## **Iditarod Dog Sledding Historic District (IDSHD) Workshop Workshop Summary and Implementation Plan Summary Comment Resolution**

In accordance with the Section 106 Programmatic Agreement for the Port MacKenzie Rail Extension (PMRE) project, the Alaska Railroad Corporation (ARRC) hosted two of three planned Iditarod Dog Sledding Historic District (IDSHD) workshops in June and July 2011. At the request of IDSHD workshop participants, the Matanuska-Susitna Borough (MSB) hosted a larger trail user meeting in October 2011. ARRC and MSB, hereafter referred to collectively as the Project Team, have worked closely to identify design changes, modifications, and/or refinements to the project that will address concerns and mitigate impacts identified during those meetings. This document summarizes meeting/workshop participants' comments and concerns, and provides the Project Team's proposed resolution. In January 2012, ARRC will host a final IDSHD Workshop, and this document will serve as the basis for discussing how mushers' (and other trail users') comments and concerns have been addressed. Following that meeting, ARRC will prepare a *Workshop Summary and Implementation Plan* for submit

**Exhibit 1: Historic Iditarod Trail crossing design before and after the IDSHD Workshops<sup>1</sup>**

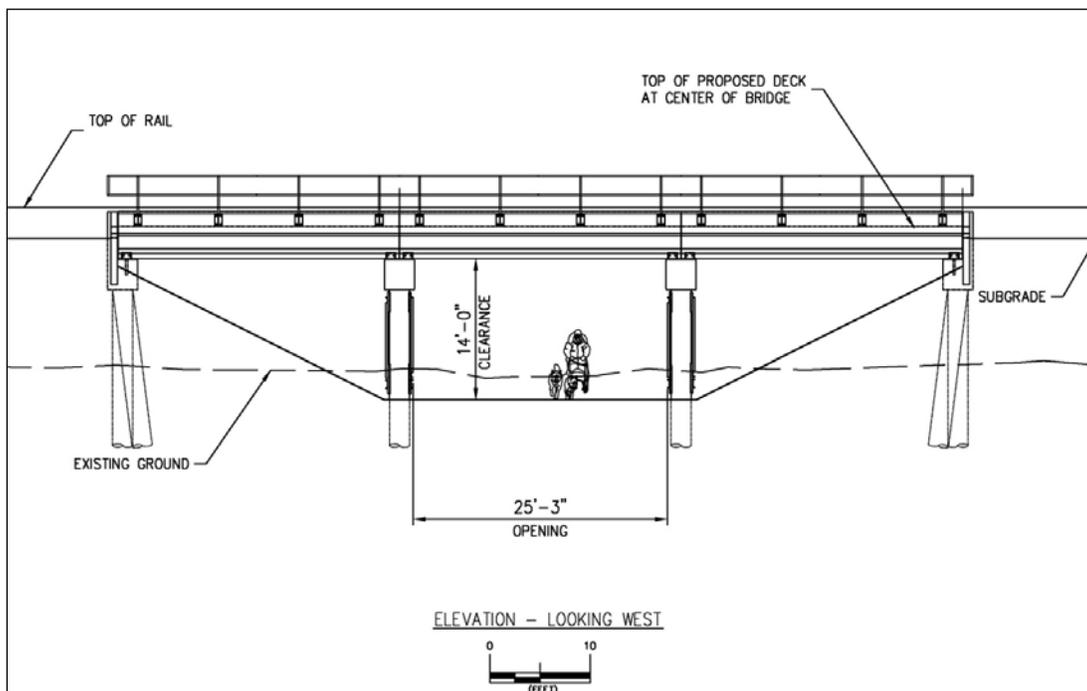
1. *The height (vertical clearance) of crossings needs to be increased to more than 12' to account for snow depth, accommodate equipment for grooming of trails, and enhance safety. The existing clearance is as low as 10' for some crossings.*

**Proposed Resolution:** The Project Team has redesigned bridges/crossings with the vertical clearance increased to a minimum of 14', whenever possible. Table 1 summarizes previously and currently proposed trail and road crossings for the PMRE project. Vertical clearances will range from 12' to over 18'. Only two crossing structures, located south of the Agricultural District, will have a vertical clearance less than 14'. One of these crossings (Crossing 14), which will be a three-span bridge providing between approximately 12' vertical by approximately 25' horizontal clearance, is adjacent to the Baker Farm Road at-grade crossing (Crossing 15) and provides an alternative crossing option in the vicinity (Table 1). The other crossing is the Figure 8 Lake Loop trailhead crossing (Crossing 16), which will be accommodated by a 19'-6" plate pipe, providing between approximately 9' and 14' vertical by 16' horizontal clearance (Table 1). A bridge crossing in this location is not practicable due to the poor soil conditions and high-railroad embankment through the area. Alternative access for over-height vehicles is provided by the access road from Lu Young Lane, south of the Bulk Material Bi-modal Facility (BMBF).

Increasing the vertical clearance under a bridge also increases the footprint of the embankment approaching the bridge, which often increases wetlands impacts. The design team has tried to strike a reasonable balance between the needs of trail users and our obligations to minimize impact to wetlands under Federal law. Exhibit 1 shows a comparison of the previously proposed Historic Iditarod Trail crossing and the currently proposed crossing that has been refined based on comments from trail users. As illustrated in this example, the vertical clearance was increased, based on comments from workshop participants, from approximately 12' to 14'.

Exhibit 2: Approach example

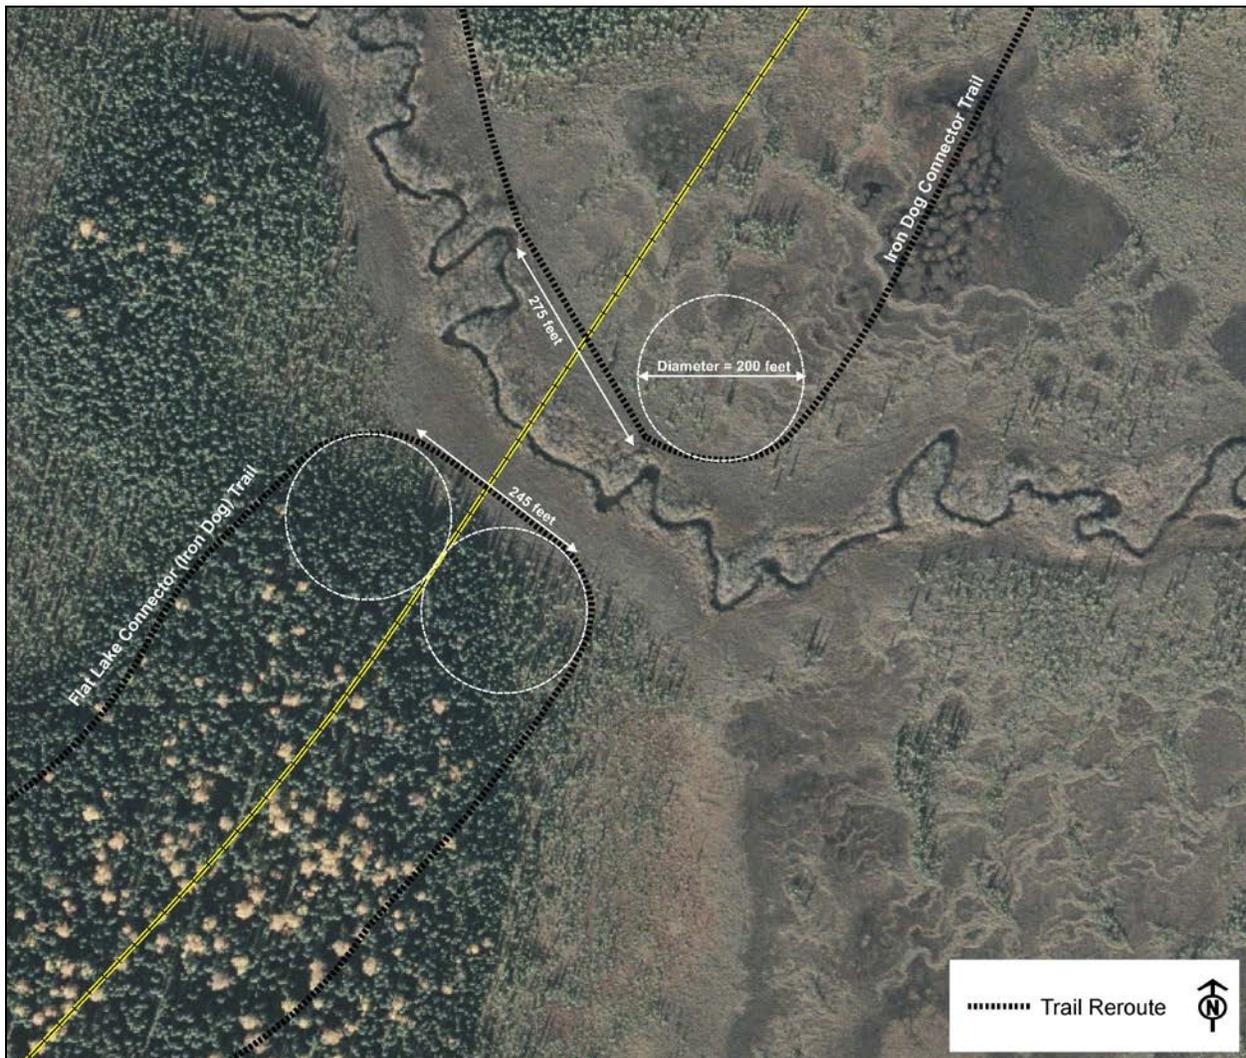
2. The length of a sled dog team with 16 to 20 dogs (approximately 85') needs to be considered during design of trail approaches to crossings to ensure curves are not too tight. (This comment was made in reference to the rerouted trails, specifically Crossing H 6.3 [Project Crossing 5]).

**Proposed Resolution:** The Project Team has been working with Sustainable Design Group to develop standards for sight distance needs and crossing approaches that will accommodate a 100' long vehicle/dog team, which requires a minimum 60' turn radius. The design standard for trail approaches to crossings includes gentle curves with turn radii between 75' and 90'. This turn radius will allow for a 100' long dog team to turn and safely pass through the structure while allowing adequate line of sight for trail users prior to passage (Exhibit 2).

**Exhibit 3: Crossing 5 (H 6.3) profile view**

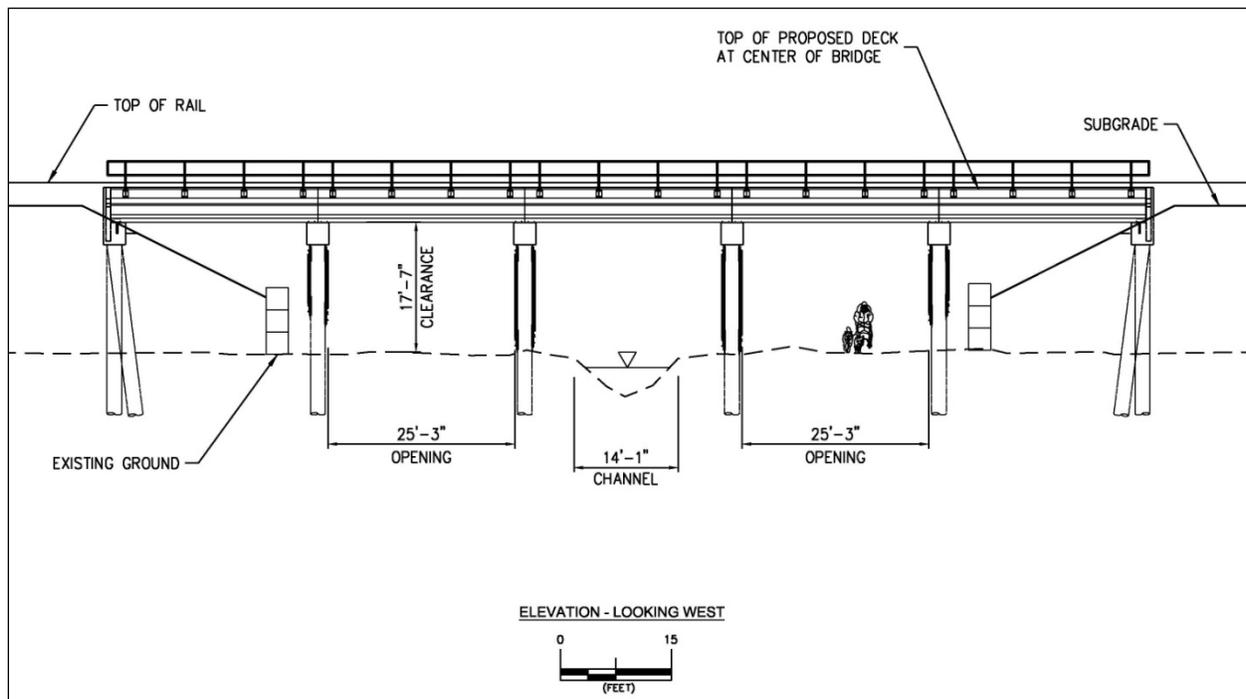
10. *Incorporate safety considerations into design for the Houston 6.3 crossing (Crossing 5). Design should account for increased traffic caused by funneling multiple trails into a single crossing and should include wider/higher openings under the bridge, a wider turn radius for the reroutes approaching the crossing location, and a good line of sight approaching and extending under the crossing.*

**Proposed Resolution:** The original crossing design at this location was to construct a three-span bridge with 12'-7.5" of vertical clearance, two spans with 14' horizontal clearance, and a center span with over 25' of horizontal clearance. The design carried forward to the MSB Trail User Open House (10/27/11) where MSB presented a five-span crossing structure with increased vertical clearance but similar horizontal clearances. Concerns of trail users attending the MSB Trail User Open House (10/27/11) were addressed by upgrading the crossing structure to provide additional horizontal clearances. The improved structure will accommodate a trail on both the north and south side of the creek, each with 25' horizontal clearance to accommodate multiple users and grooming equipment with a vertical clearance of more than 17'. Exhibit 3 (see Comment 8 above) shows the most recent proposed design for Crossing 5.

**Exhibit 4: Proposed Iron Dog Connector Trail Reroute and Crossing (Crossing 5)**

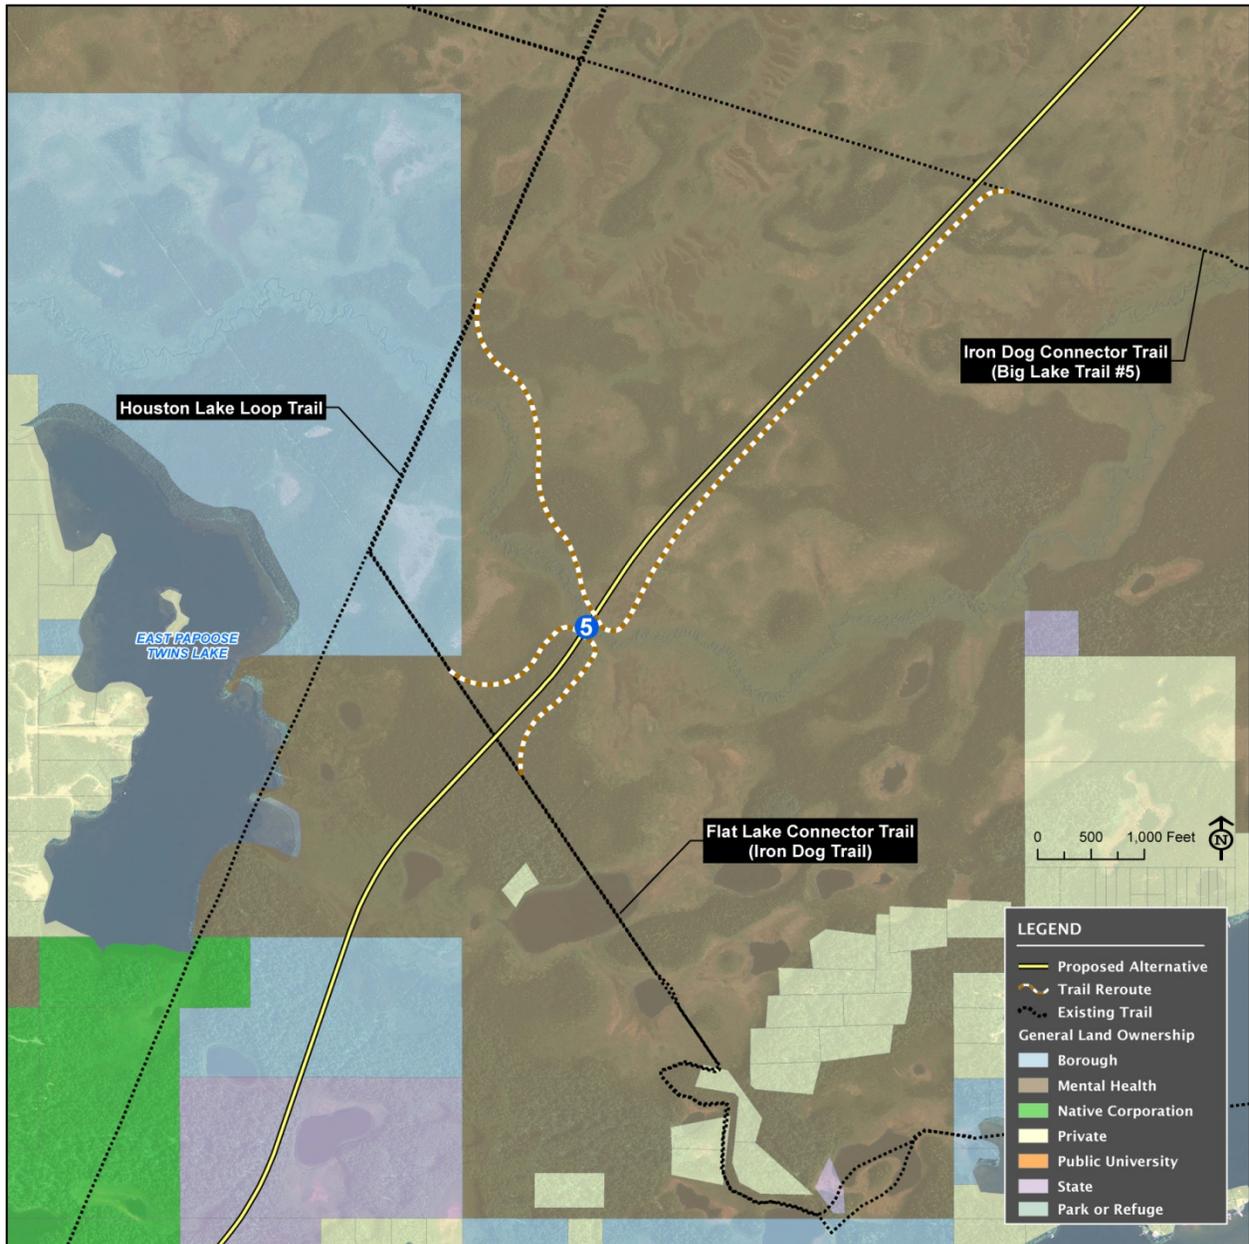
8. Provide a crossing for the Iron Dog Connector Trail (Big Lake Trail #5 in MSB Trails Plan)

**Proposed Resolution:** The Iron Dog Connector Trail is identified in MSB trail plans as a winter use only trail as it traverses portions of wetlands and lakes in the project area. Due to safety concerns, wetland and regulatory concerns, tree cover, and topography (see Comment 5), a crossing is not a good option at its current location. Therefore, the Project Team proposes to reroute the trail to the northern usable span of a five-span bridge with approximately 25' of horizontal clearance and 17' of vertical clearance (Crossing 5; Exhibit 3). The rerouted trail will be reconnected with the Houston Lake Loop Trail north of the rail embankment (see Exhibit 4).

**Exhibit 5: Possible Iditarod Race Trail Reroute and Crossings**

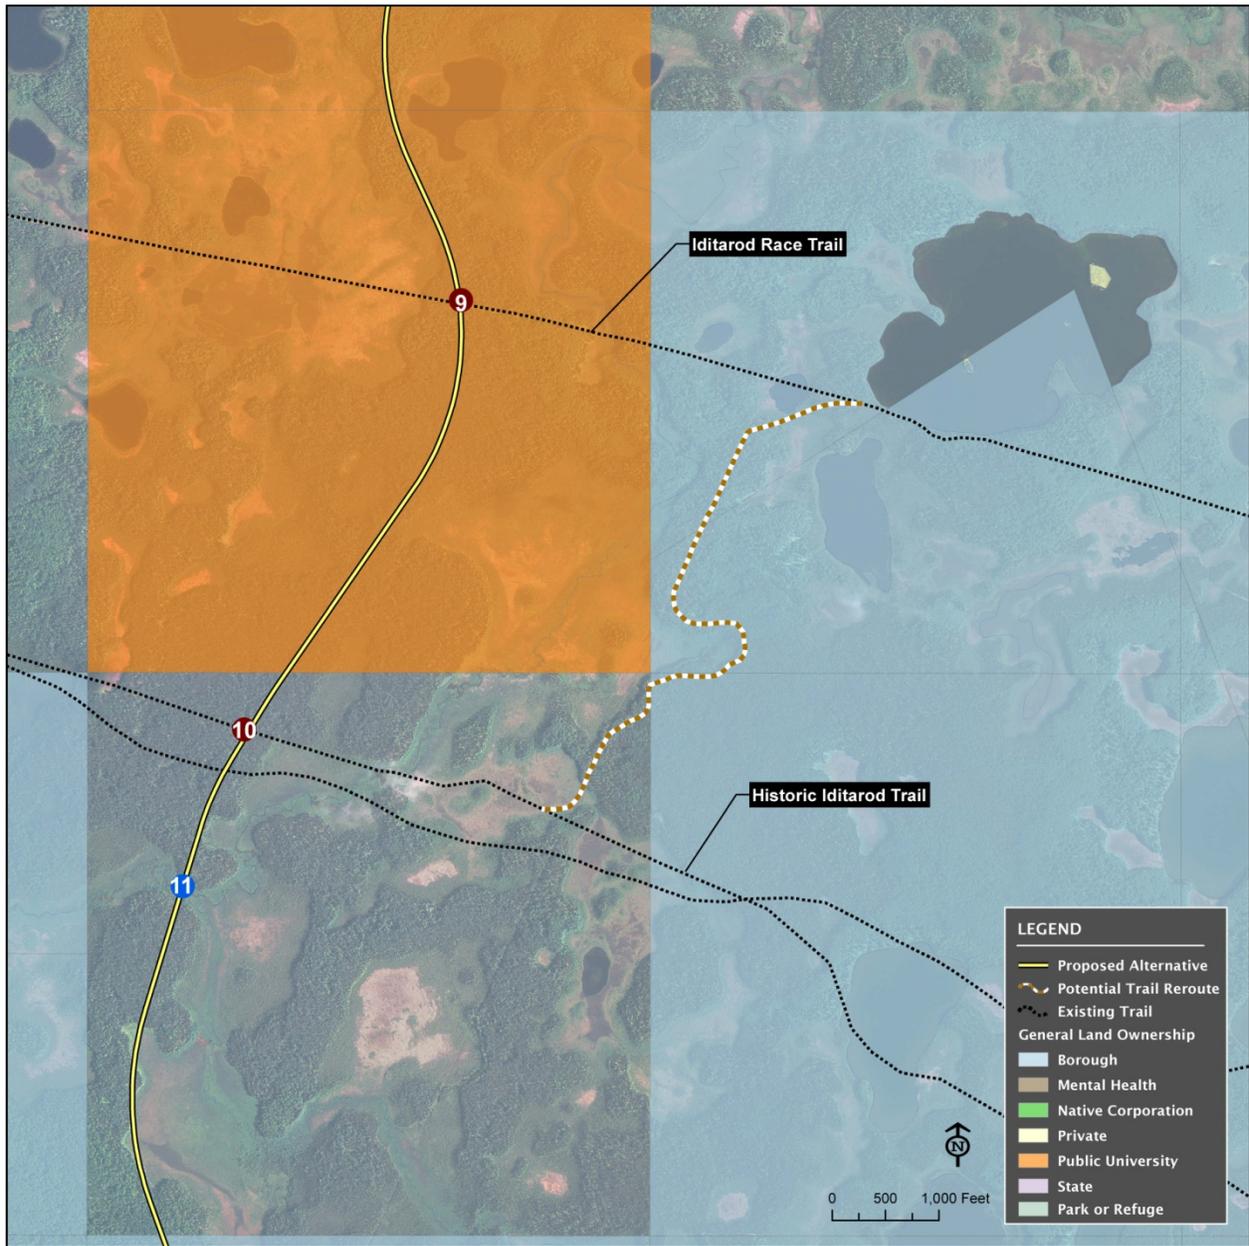
*11. Provide a crossing for the Iditarod Race Trail and obtain an easement from the University of Alaska for this trail should one not currently exist. This trail has reportedly hosted 20 Iditarod races and is used more frequently/regularly than the Historic Iditarod Trail. A separated grade crossing (bridge) is preferred, but if a bridge is not possible, an at-grade crossing would be better than no crossing at all.*

**Proposed Resolution:** Approaches to a crossing for the Iditarod Race Trail would be on University of Alaska land. The MSB is working with UA to secure an easement at this location if no easement currently exists. The crossing (Crossing 9) would be a typical three-span bridge with a minimum 14' vertical clearance, and approximately 25' of horizontal clearance in the center span (see Exhibit 1 as an example of a typical three-span bridge and Table 1). This crossing will involve excavation and grading of the trail to obtain 14-feet of vertical clearance at the current crossing location. As the trail passes beneath the embankment at a slight angle, only 20 feet of the crossing width will be usable for the trail. Approach improvements would include widening the trail in the vicinity of the crossing.

If negotiations with UA to secure an easement are unsuccessful, a crossing would not be provided for the Iditarod Race Trail as it would encourage trespassing on UA property. The Race Trail would be rerouted to the Historic Iditarod Trail, which would be upgraded/improved to accommodate the potential increase in users (Exhibit 5; see Comment 12).

**Exhibit 6: Connectivity between Crossings 7 and 10**

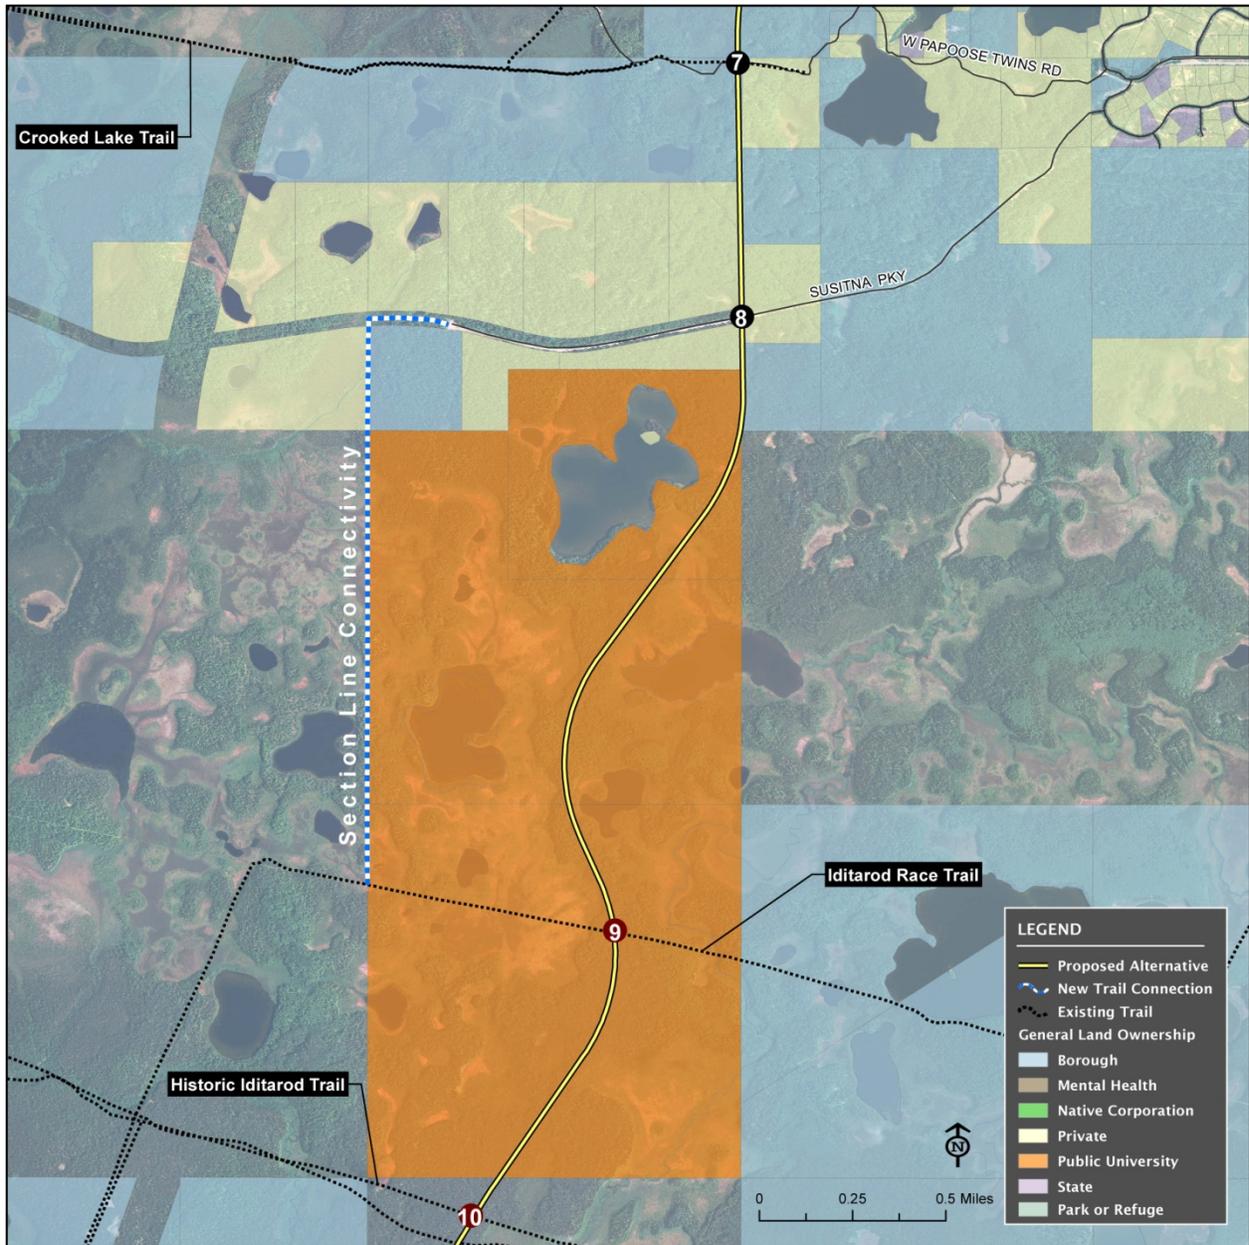
14. Provide north-south trail along one or both sides of the proposed ROW to help maintain connectivity. Even if there is not a dedicated trail, people would still likely travel along this area.

Most of the existing trails identified both in the Final Environmental Impact Statement (FEIS) and trails workshops that provide north-south movement will remain intact. The Project Team believes that the existing trail system west of the proposed rail corridor provides a north-south corridor (Figure 3 of Attachment 1). However, one area of concern for north-south connectivity has been identified between Crossings 7 and 10 (Exhibit 6). This area demonstrates the biggest gap in connectivity and is owned primarily by UA. The Project Team has developed an alternative corridor for north-south travel in this area that may work for trail users and property owners (see Exhibit 6).

Exhibit 9: Kiosk schematic (Department of Natural Resources)

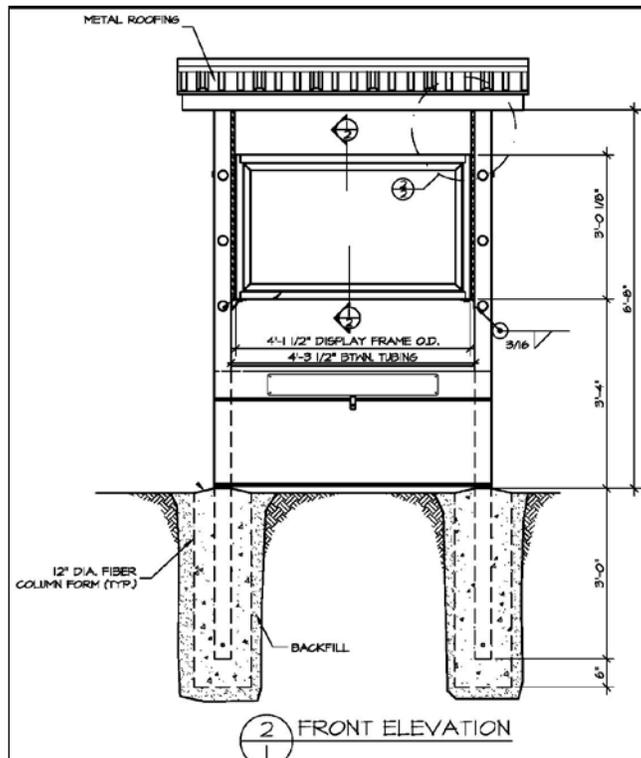
15. Adequate signage needs to be provided to warn trail users. Consider standard snow machine/dog sledding trail signage as seen on Alaska State Parks Snowmobile Trail Advisory Committee (SnoTRAC) website, not road side signs.

Kiosks with trail maps will be placed at key locations and will aid trail users by identifying trail reroutes and showing available trail connections. An example of a kiosk located on the Willow trails system is illustrated in Exhibit 8. A proposed design for the kiosks is illustrated in Exhibit 9.
